ROCKER ARM SHAFT

Application of Modifications

This changes have been applied on the production models starting with the following engine serial numbers.

Fig. 1 (1) Cylinder head cover
(2) Sealing washer
(3) Right rocker arm shaft
(4) Left rocker arm shaft

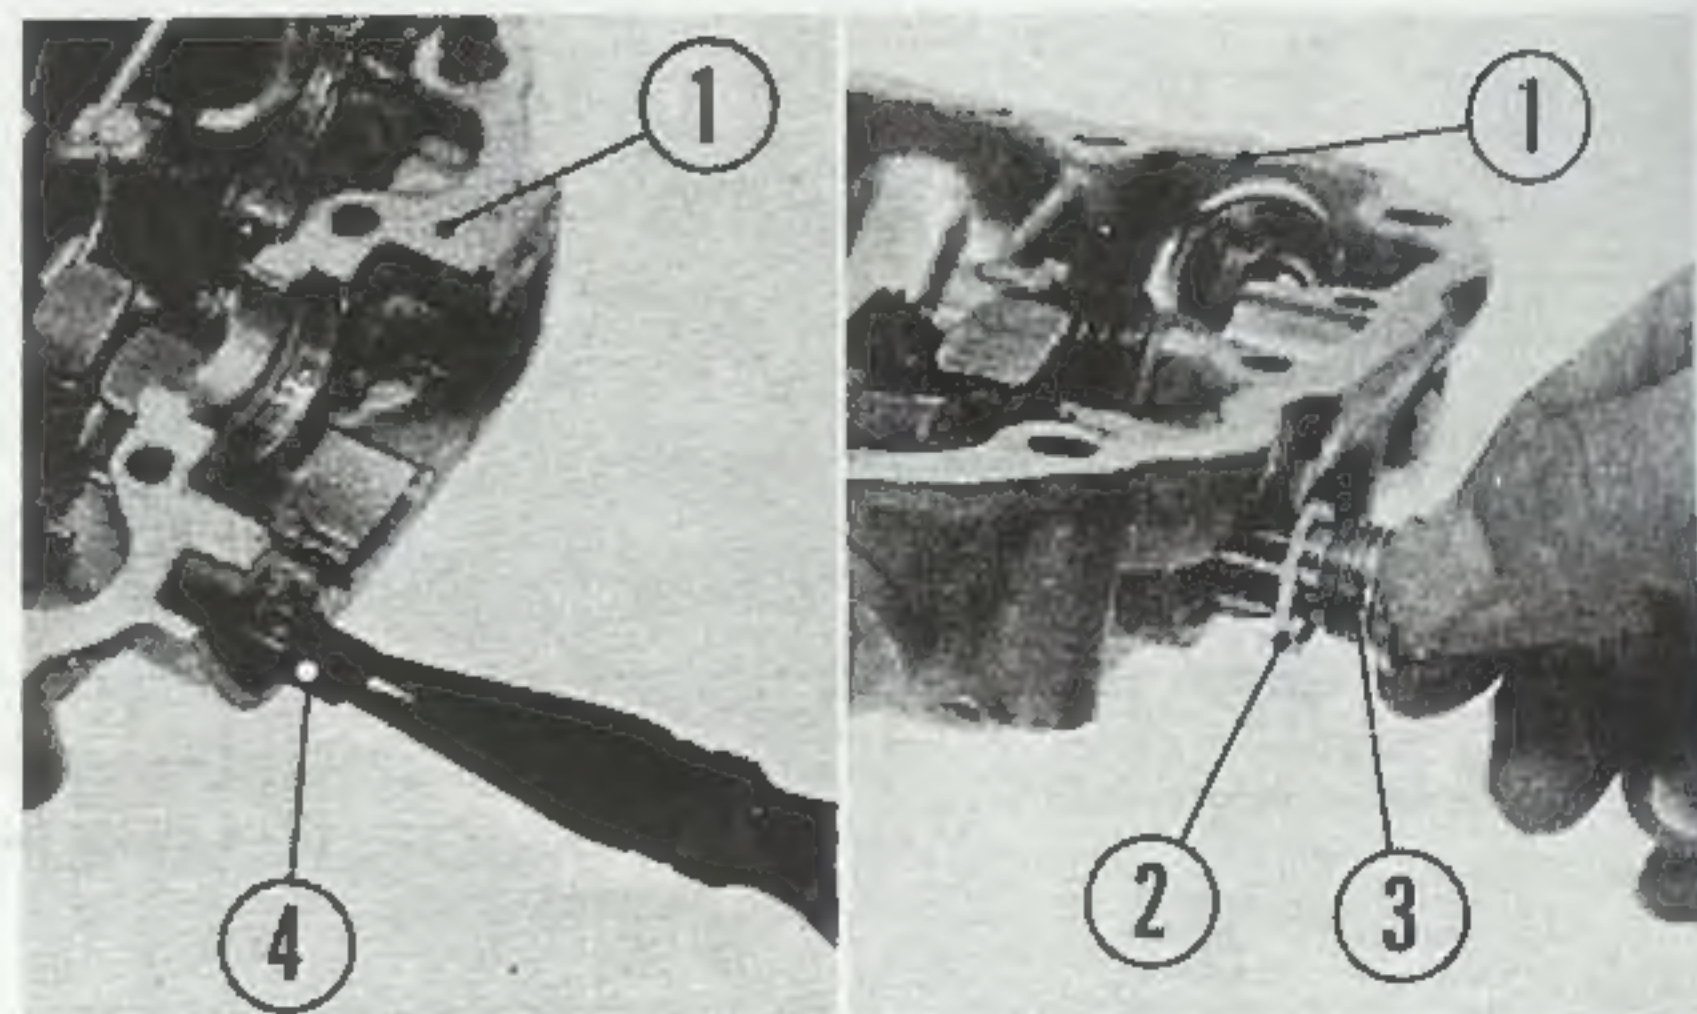
TYPE	ENGINE No.
CB250 K5/G	6022201
CB360G	1088381
CL360K1	2008449
CB360T	2031164

Except that Right rocker arm shaft is removed only loosening bolt.
